Prairie Island Nuclear Generating Plant, Units 1 and 2
Dockets 50-282 and 50-306
Renewed License Nos. DPR-42 and DPR-60

License Amendment Request for Spent Fuel Pool Criticality Changes

Enclosure 2
Marked-Up Technical Specification Pages

Figure 3.7.17-1
Spent Fuel Pool Unrestricted Region Burnup and Decay Time Requirements

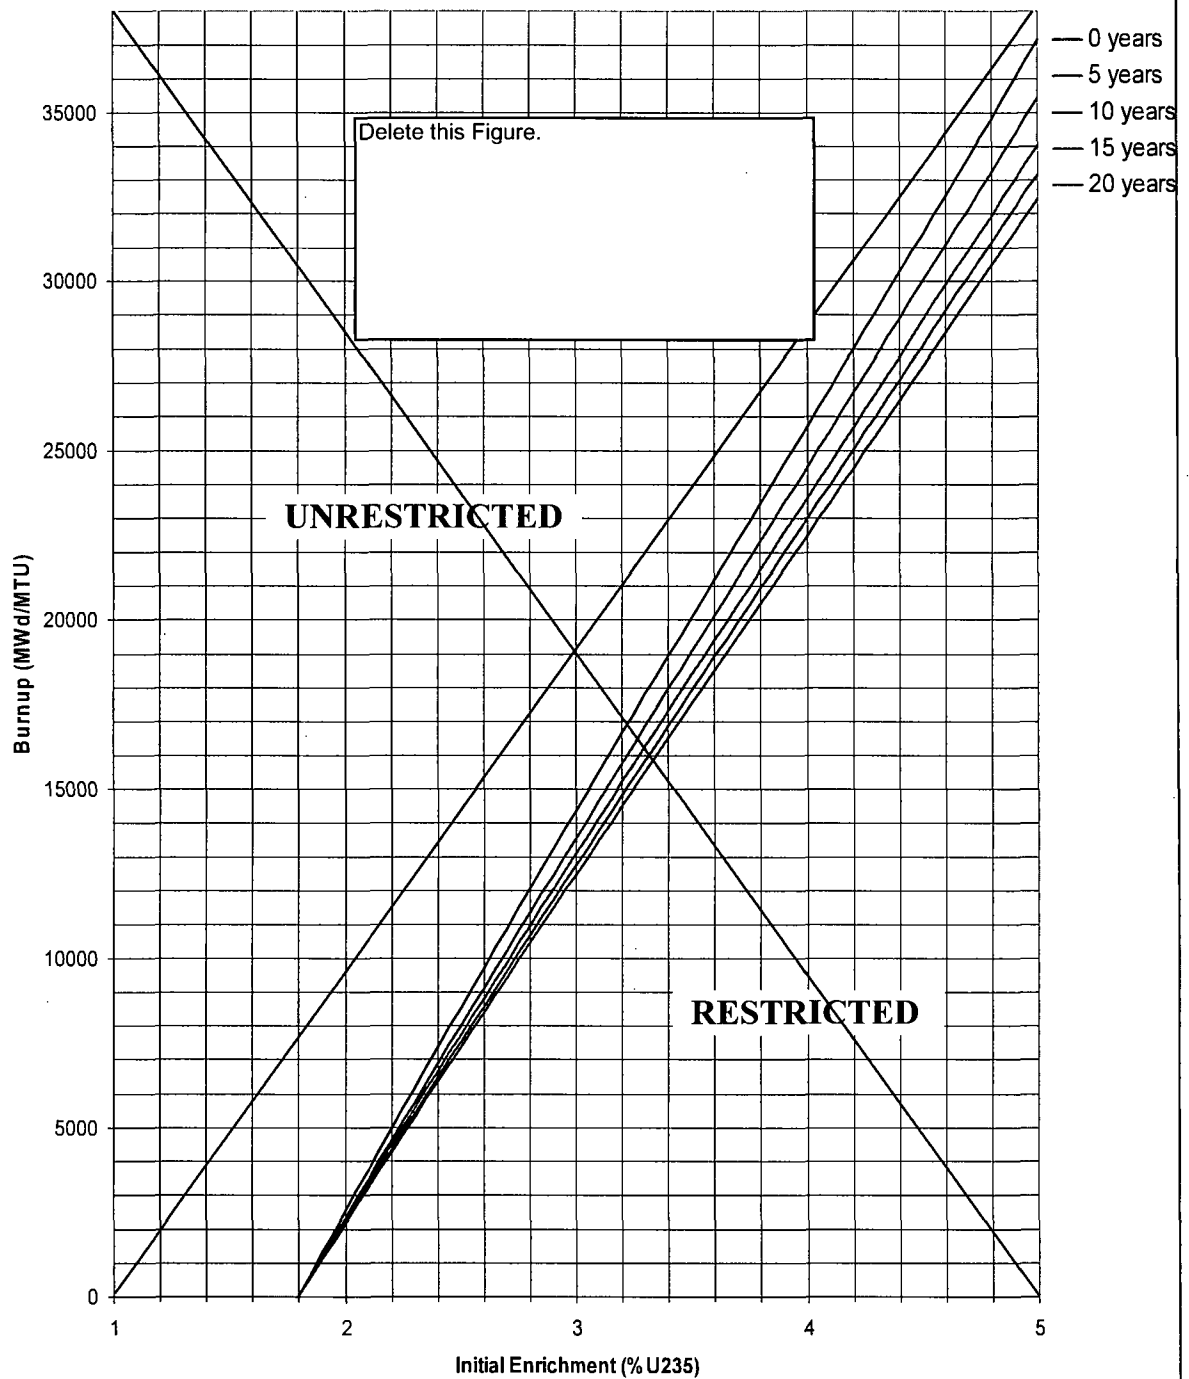
The proposed change will replace all previous loading restrictions in TS 3.7.17 and 4.3.1.1 with new loading restrictions. Specific to TS 3.7.17, the proposed change will remove TS Figure 3.7.17-1 and refer to TS 4.3.1.1 for all SFP loading restrictions; thereby eliminating the concept of "restricted" and "unrestricted" loading in the SFP.

The proposed revision to TS 3.7.17 eliminates Figure 3.7.17-1 and the related terms of "restricted" and "unrestricted". In effect, the new loading restrictions have made this concept of "unrestricted" storage obsolete because there are no "unrestricted" fuel categories in the proposed TS. Even a fuel assembly that meets the high-burnup Category 6 must meet other restrictions. For example, it must be placed in a qualified array and meet the prescribed interface requirements. Therefore, the concept of "restricted / unrestricted" storage is eliminated and replaced with a complete set of new loading restrictions embodied entirely in TS 4.3.1.1.

- d. A nominal 9.5 inch center to center distance between fuel assemblies placed in the fuel storage racks;
- e. New or spent fuel assemblies with a combination of discharge burnup, initial enrichment and decay time in the "unrestricted range" of Figure 3.7.17-1 may be allowed unrestricted storage in the fuel storage racks; and

- f. New or spent fuel assemblies with a combination of discharge burnup, initial enrichment and decay time in the "restricted range" of Figure 3.7.17-1 will be stored in compliance with Figures 4.3.1-1 through 4.3.1-4.

, fuel inserts, and hardware loaded in accordance with Figure 4.3.1-1.

Figure 4.3.1-1
Spent Fuel Pool Burned/Fresh Checkerboard Cell Layout

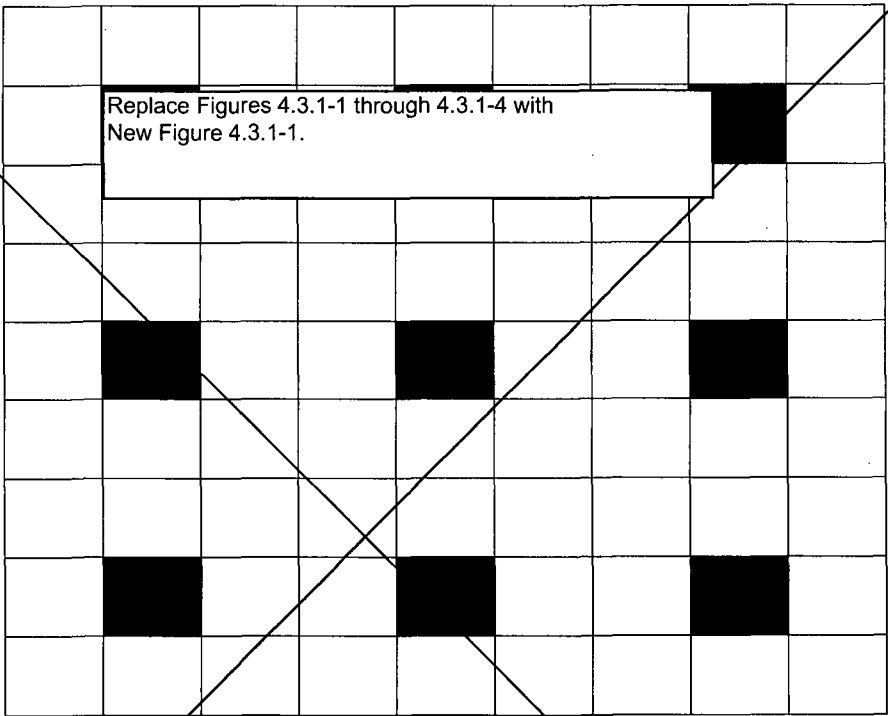
The proposed change will modify sub-item (e) to apply the new loading requirements of TS Figure 4.3.1-1 and expand the scope to include fuel inserts and hardware. Sub-item (f) is eliminated entirely. Accordingly, the proposed change will replace current loading restrictions in TS Figures 4.3.1-1 through 4.3.1-

4 with new loading restrictions embodied by TS Tables 4.3.1-1 through 4.3.1-3 and TS Figure 4.3.1-1.

- a. ~~The first storage configuration utilizes a pattern to accommodate new or low burnup fuel with maximum enrichment of 5.0 w/o U-235. This configuration stores "burned" and "fresh" fuel assemblies in a 3x3 checkerboard pattern as shown in Figure 4.3.1-1. Fuel assemblies stored in "burned" cell locations are selected based on a combination of initial enrichment, discharge burnup and decay time (Figures 4.3.1-3 and 4.3.1-4). The criteria for the fuel stored in the "burned" locations is also dependent on the presence of rods containing gadolinium in the center "fresh" fuel assembly. The use of empty cells is also an acceptable option for the "fresh" and "burned" cell locations. This will allow the storage of new or low burnup fuel assemblies in the outer rows of the spent fuel storage racks because the area outside the racks can be considered to be empty cells.~~

~~Fuel assemblies that fall into the restricted range of Figure 3.7.17-1 are required to be stored in "fresh" cell locations as shown in Figure 4.3.1-1. The criteria included in Figure 3.7.17-1 for the selection of fuel assemblies to be stored in the "fresh" cell locations is based on a combination of initial enrichment, decay time and discharge burnup.~~

The proposed Figure 4.3.1-1 makes provisions for spent fuel pool contents that were not previously included in the TS. These contents include consolidated rod storage canisters, failed fuel baskets, and fuel assembly inserts.

- Figure 4.3.1-1 provides the Spent Fuel Pool Loading Restrictions. Once the fuel assemblies are categorized per the Tables in TS 4.3.1, this figure describes the loading configurations (described as “arrays”) that ensure subcriticality criteria are satisfied. These proposed loading restrictions address new entities that had not been previously subject to TS: (1) consolidated rod storage canisters (CRSCs) and associated non-fissile hardware, (2) fuel rod storage canisters (FRSCs), (3) failed fuel pin baskets (FFPBs), and (4) fuel assembly inserts. In addition, one array (Array G) takes credit for the insertion of a Rod Cluster Control Assembly (RCCA) in a spent fuel assembly, whereas RCCAs had not been previously credited. This figure is an output of the SFCA.

Figure 4.3.1-2
Spent Fuel Pool Checkerboard Interface Requirements

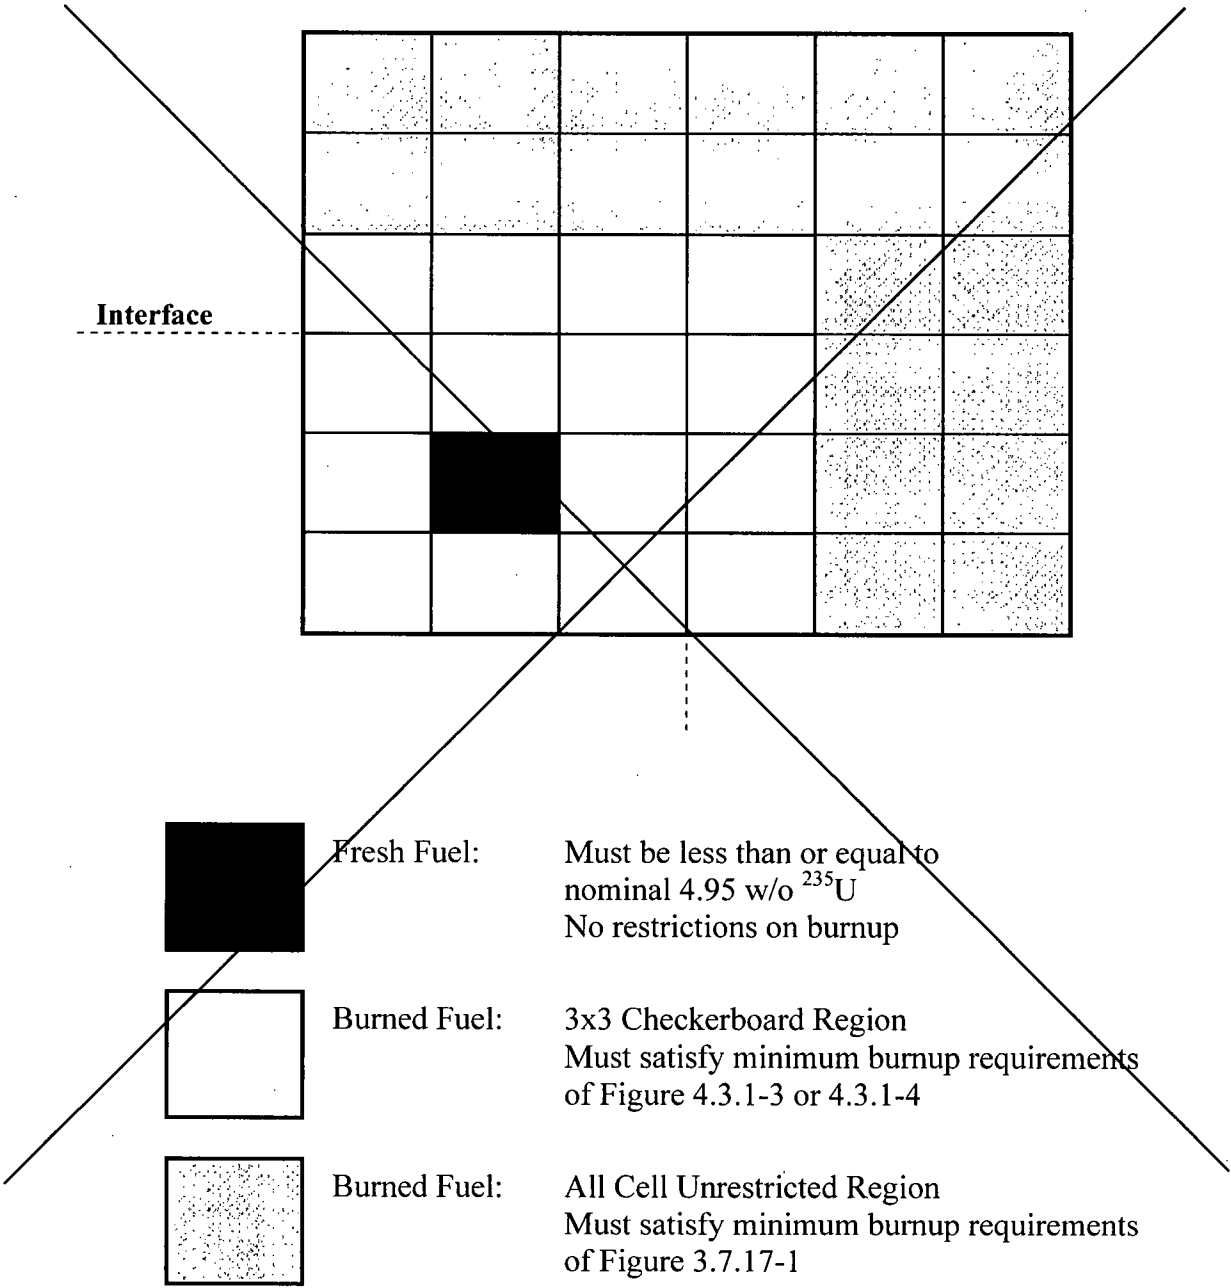
- b. ~~The interface must be configured such that there is one row carryover of the pattern of burned assemblies from the checkerboard region into the first row of the unrestricted region (Figure 4.3.1-2).~~

Figure 4.3.1-3
Spent Fuel Pool Checkerboard Region Burnup and Decay Time Requirements
- No GAD

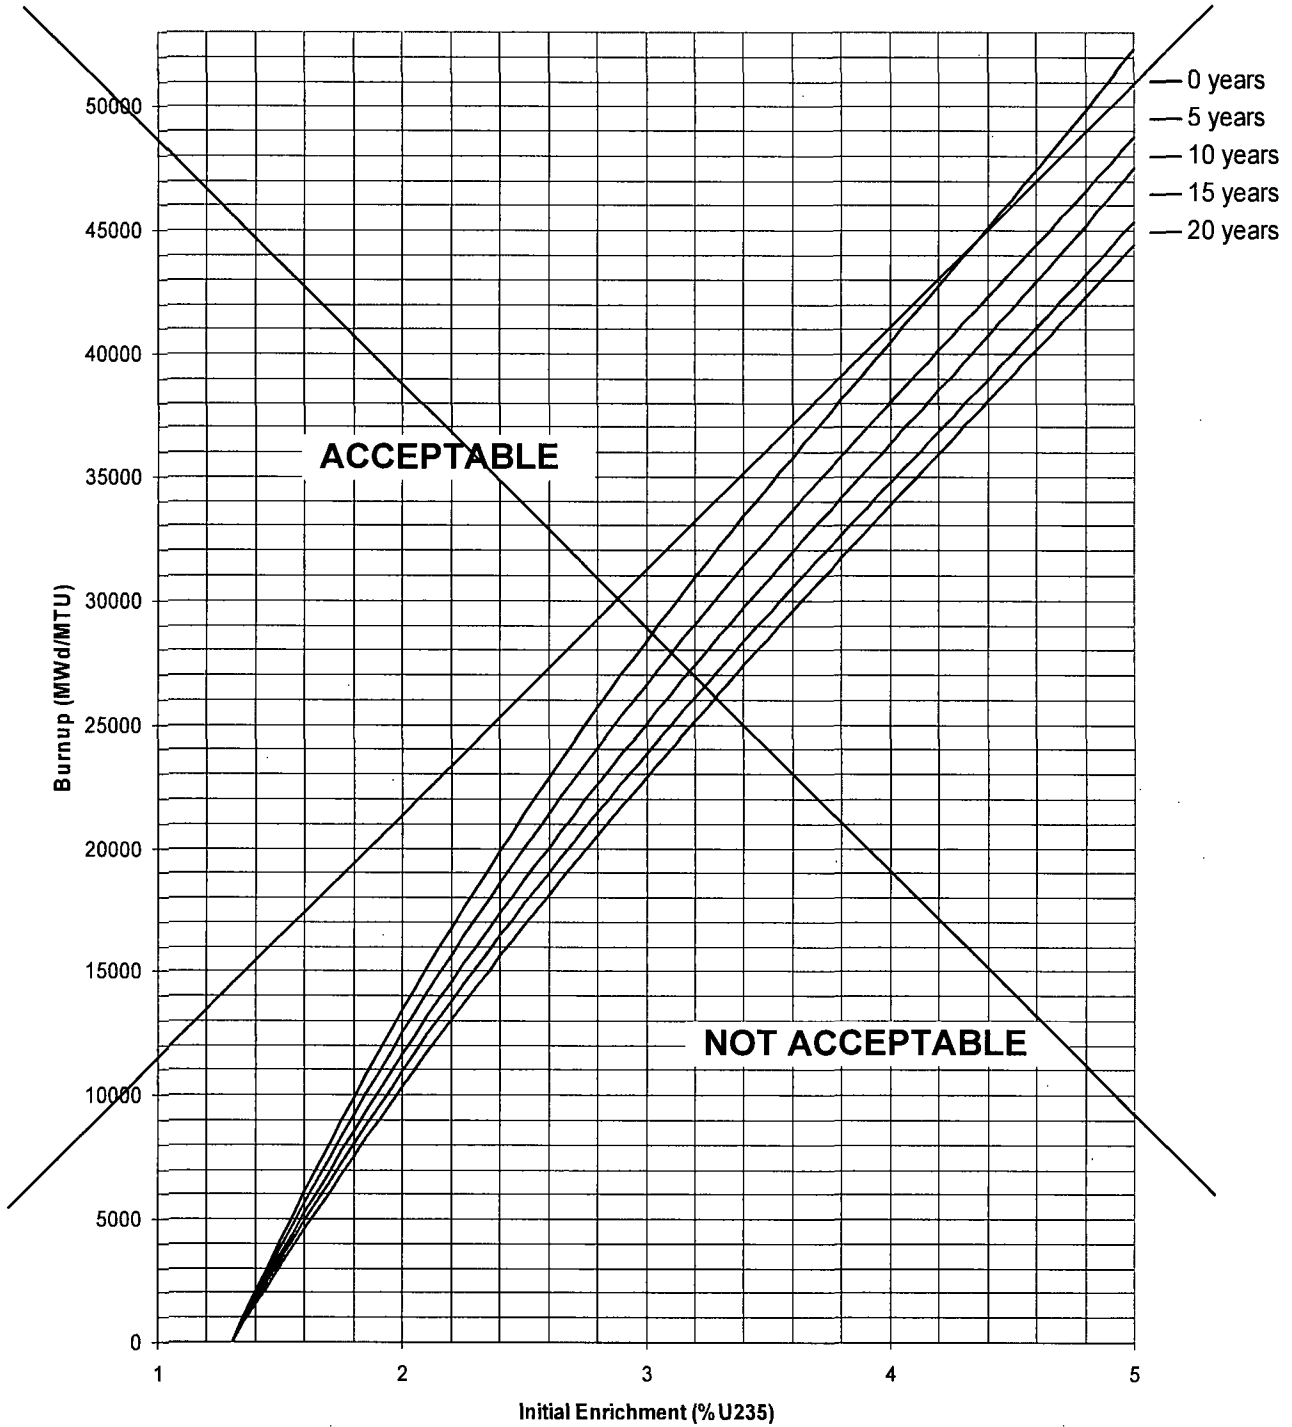
Burned Fuel: Must satisfy minimum burnup requirements of
Figures 4.3.1-3 or 4.3.1-4 depending on
presence of GAD rods in fresh fuel
